# CITY OF CHARLESTON TRC COMMENTS/RESULTS

UNION PIER

PUD MASTER PLAN

PUD2023-000025

38. Exhibit A.5 – Height District Plan.

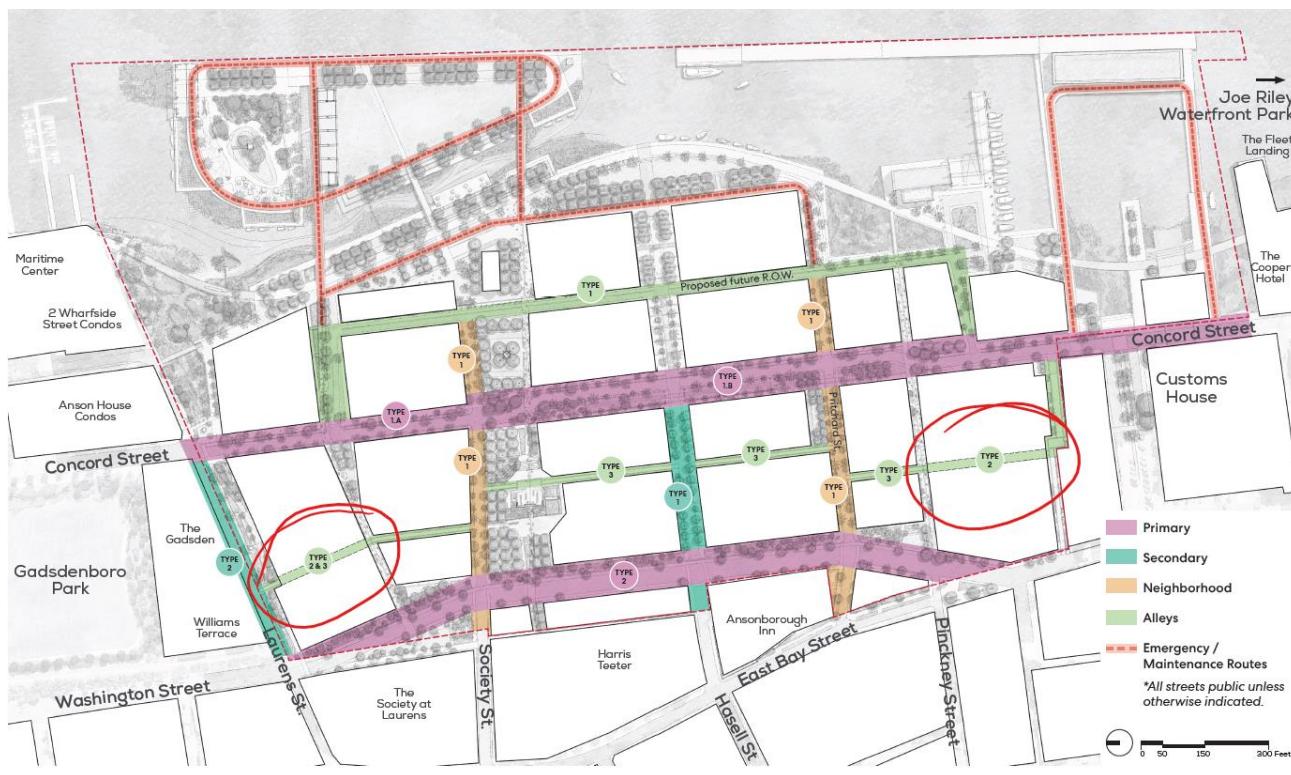
- a. Provide a new exhibit that models the proposed height district massing as it relates to newly shown proposed grade changes. This exhibit should also include existing buildings. The proposed grade changes provide much needed information, but we now have additional questions.

- b. See the redlined exhibit below and the previously provided height revisions recommended by Staff.
  - i. To respect the context (height) of existing neighboring buildings to the south and north:

- For the blocks closest to the Customs House – the height of new buildings shall not exceed the parapet height of the Customs House (see map below). Include a notation to this effect.

- For the blocks closest to the Anson House, The Gadsden, and Williams Terrace – height of new buildings shall not exceed the parapet height of the aforementioned buildings (see map below). Include a notation to this effect.

- ii. Revise the heights for blocks closest to the water as shown on the map below and in previous staff comments.
  - iii. Revise the heights for the block closest to East Bay and Market as shown on the map below and in previous staff comments.

- iv. The Planning Dept may have additional comments regarding proposed building heights once additional information is provided on the site section exhibits.

- v. Provide a chart that indicates the distribution of heights/stories over the entire developable footprint (i.e., 3 stories = X%, 6 stories = X%).
